CONTRACT NO. 1760 G, E, H, P

CSO BYPASS AND DISINFECTION

ADDENDUM NO. 5

ALLEGHENY COUNTY SANITARY AUTHORITY
 WASTEWATER TREATMENT PLANT
 CSO BYPASS AND DISINFECTION PROJECT
 842-I-01
**SODIUM BISULFITE
 PIPING & INSTRUMENTATION DIAGRAM**

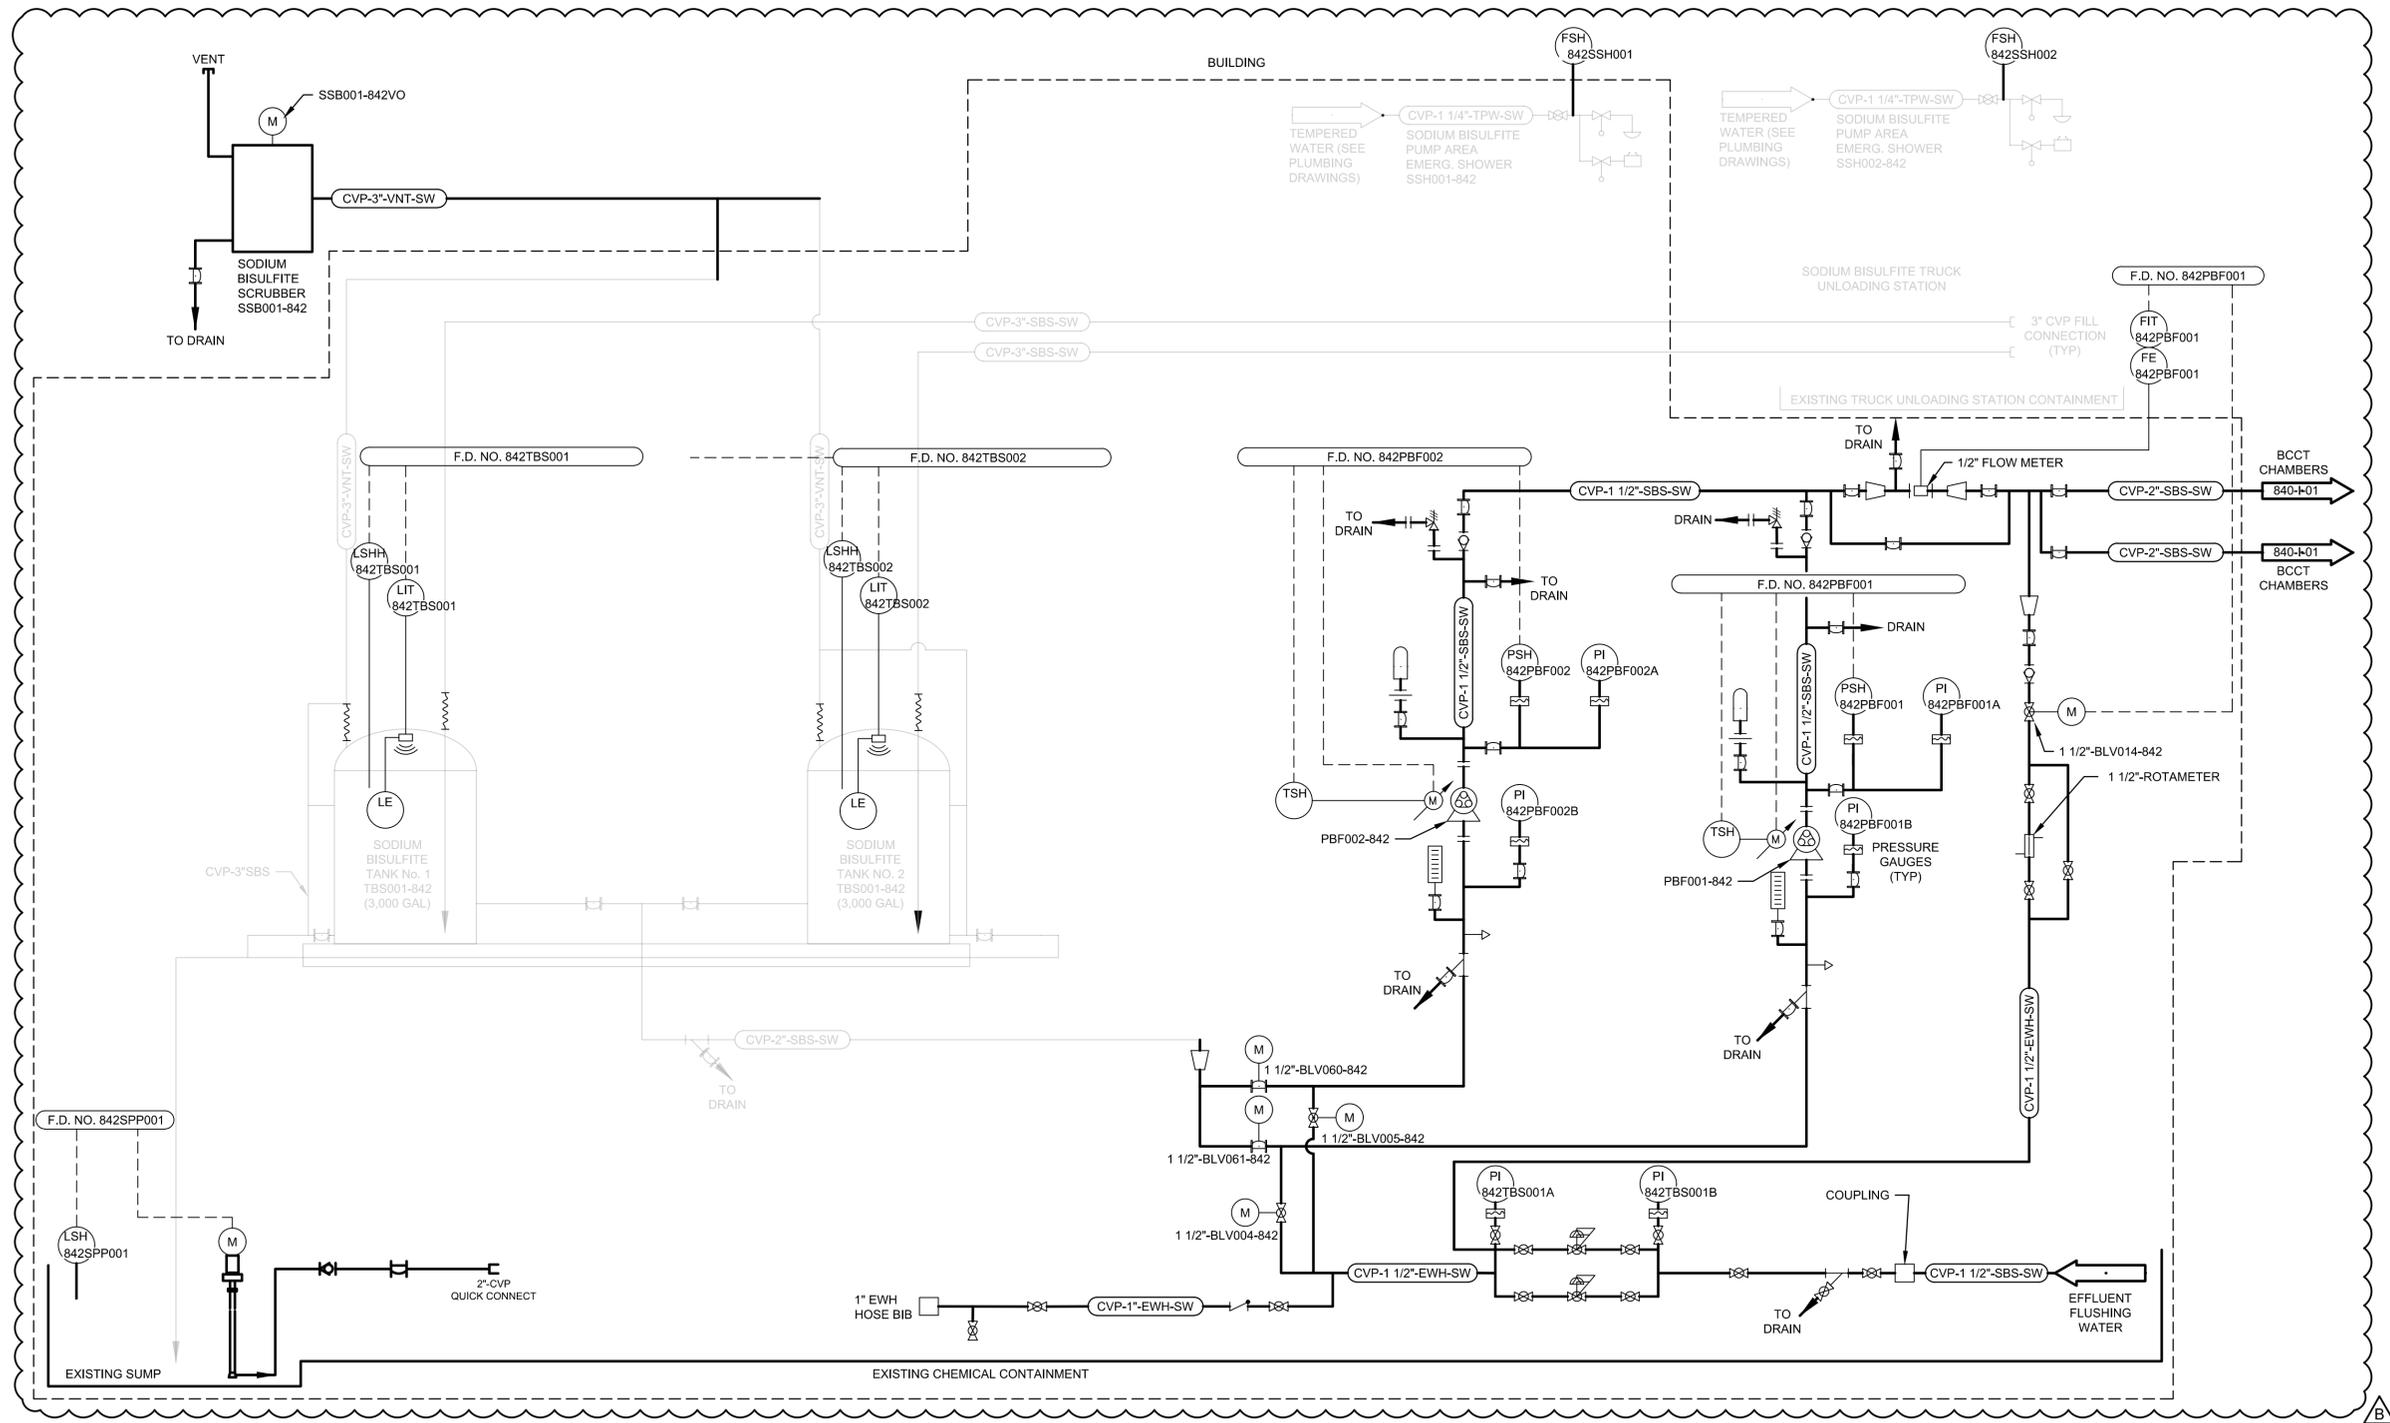
8. Replace drawing 842-ET-10 with the attached updated sheet.
9. Replace drawing 842-I-01 with the attached updated sheet.
10. Replace drawing 842-M-41 with the attached updated sheet

POLYGONAL SKYLIGHT CURB DETAIL
SCALE : 3"=1'-0"
3
865-A-11

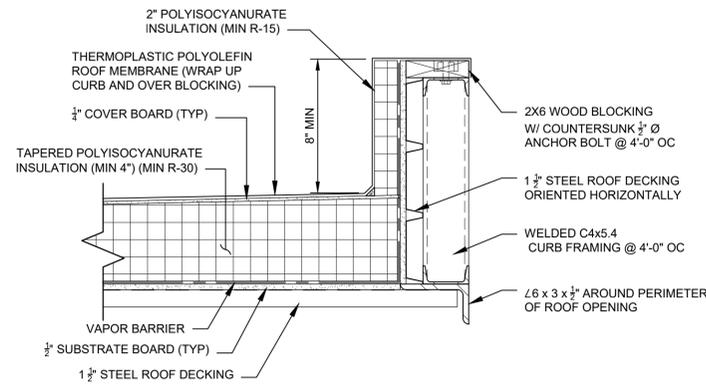
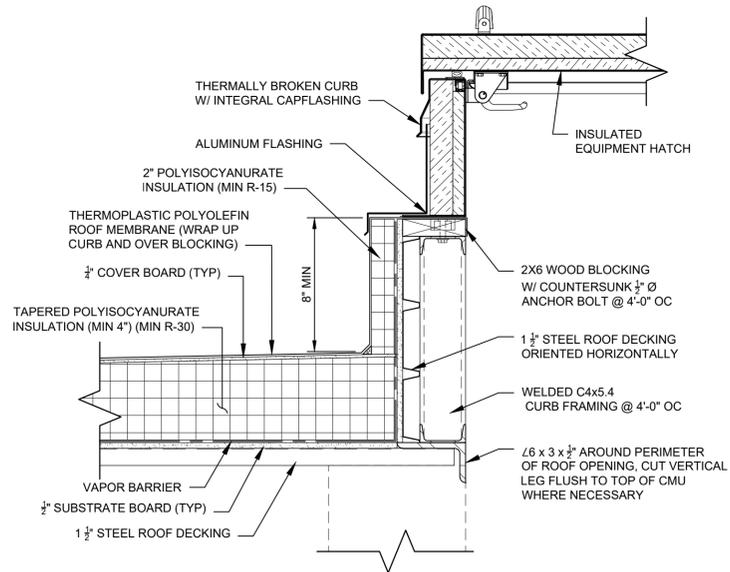
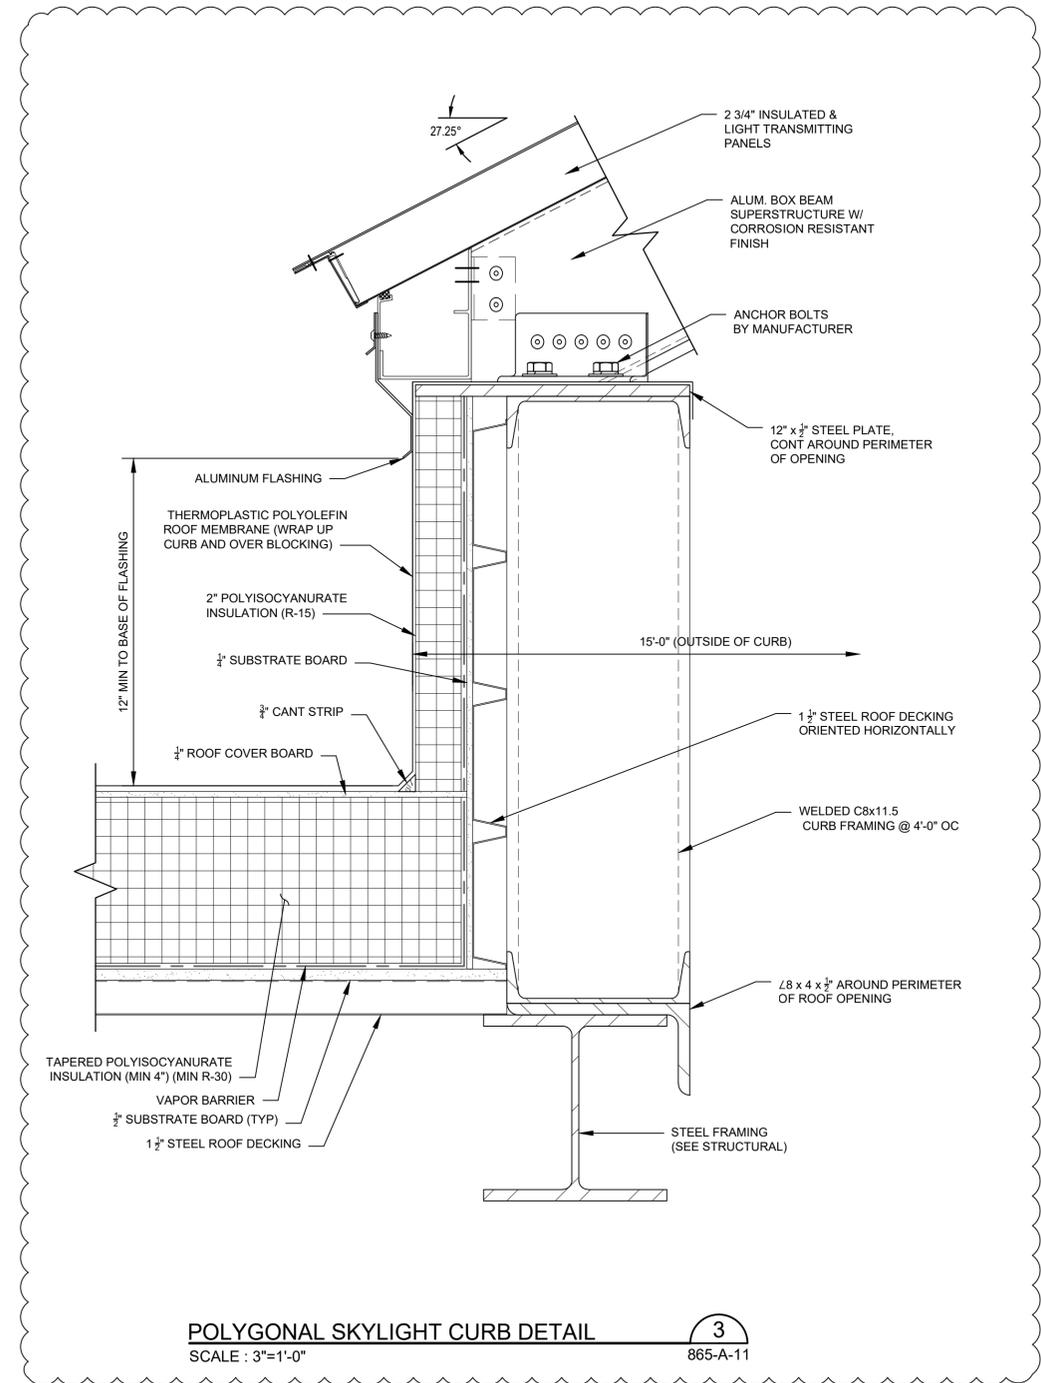
11. Replace drawing 865-AD-62 with the attached updated sheet.
12. Replace drawing 865-EZ-01, with the attached updated sheet.
13. On drawing 900-EM-03, replace Feed Pump Note No. 1 with “VFD provided by pump supplier”.

Part 2). The curb detail for the skylights should be revised. The wood blocking will interfere with the structural connection and the top plate member must be 1/2" thick steel or greater for fastening.

Answer: 1) Refer to spec changes above. 2) Refer to updated drawing 865-AD-62 3) No additions to the specification will be made at this time.

SODIUM HYPOCHLORITE FEED PUMPS WIRING SCHEMATIC

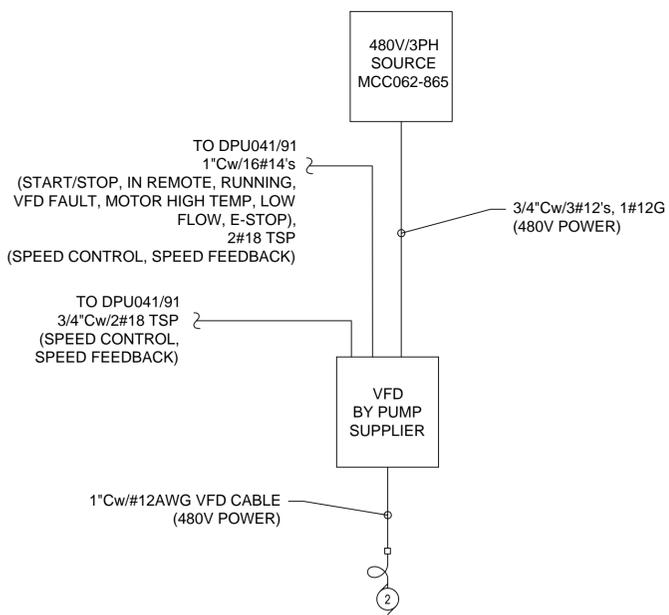
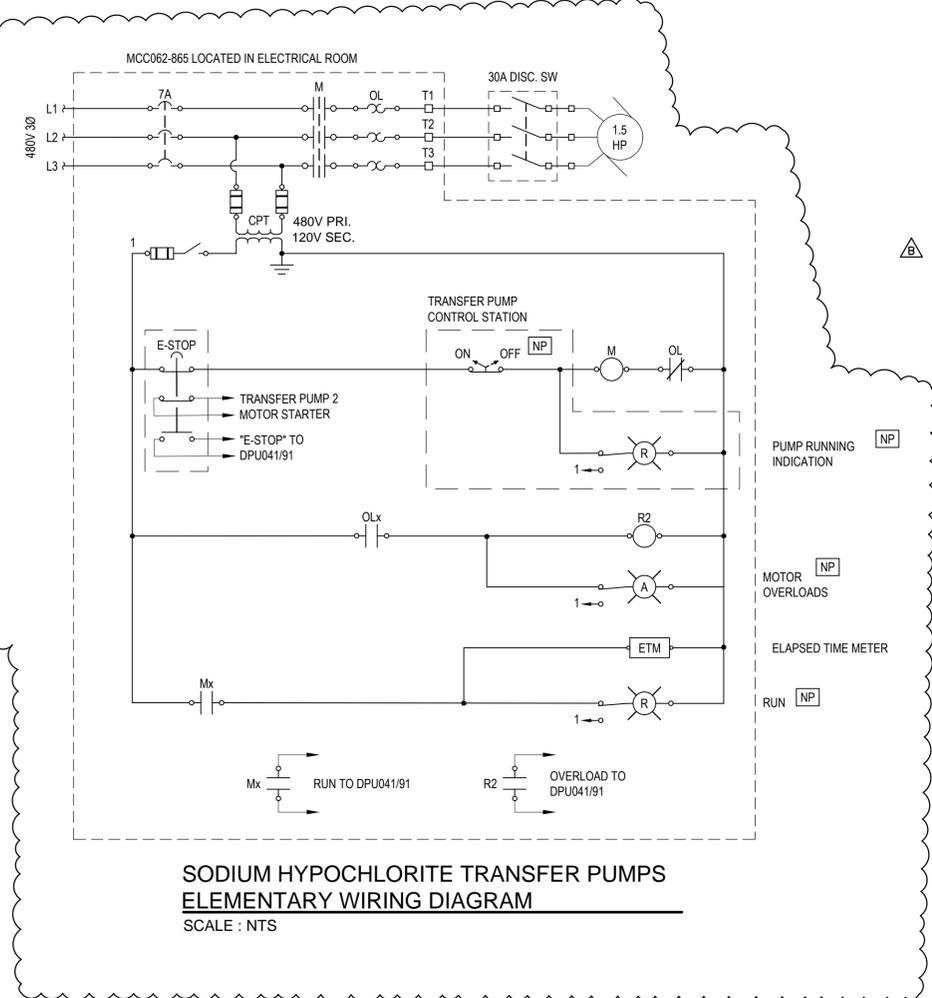
162. Question: Controls Panels: In Addendum 3 Question 70 confirms that the Electrical Contractor is responsible for supplying control stations for the Sodium Hypochlorite Transfer Pumps No. 1 and 2 on sheet 320 and Sodium Hypochlorite Feeds Pumps No. 1 through 4. We cannot find a Bill of Materials, wiring diagram or Panel General Arrangement on the drawings for these control panels. Can this information be provided?

Answer: Sodium Hypochlorite feed pumps are controlled via VFDs which are being provided by the pump supplier. Refer to the updated schematic and elementary diagram on Drawing 865-EZ-01.
